February 22, 2018

# **Aledo Groves; D1 Fitness Facility**

## ADDENDUM #1

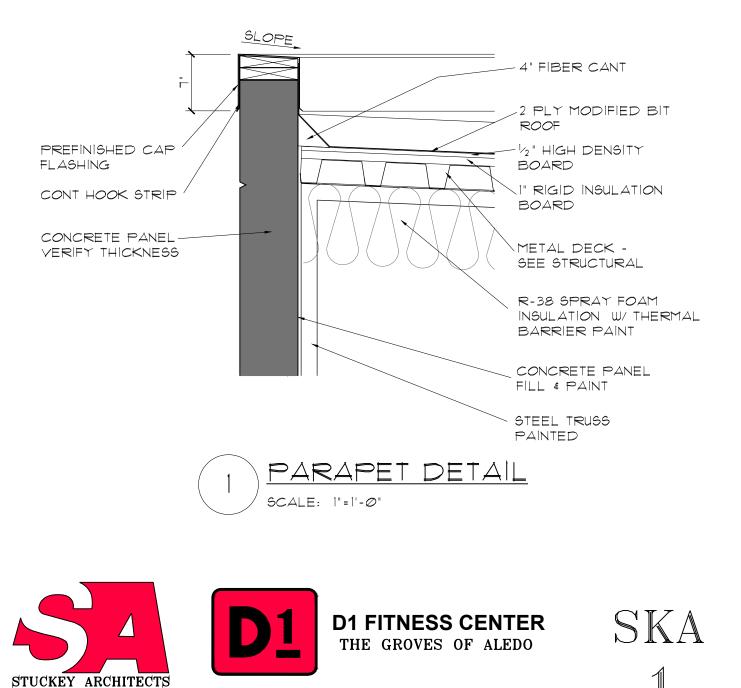
- 4. Add exterior caged roof access steel ladder on the north side between doors 12&13. See SKA-2
- 5. The use of larger steel sections is acceptable with approval of the structural engineer.

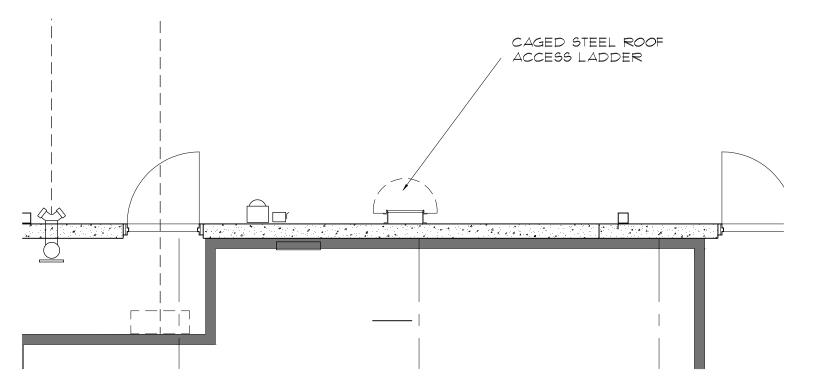
- 26. Locker Room Benches: 84"L x 18"H x 9.5"D bench equal to Salsbury Industries # 77787.
- 27. Paving & Retaining Walls: Reference B1.2 for paving to be installed. See SKA-3 for the scope of the retaining wall.
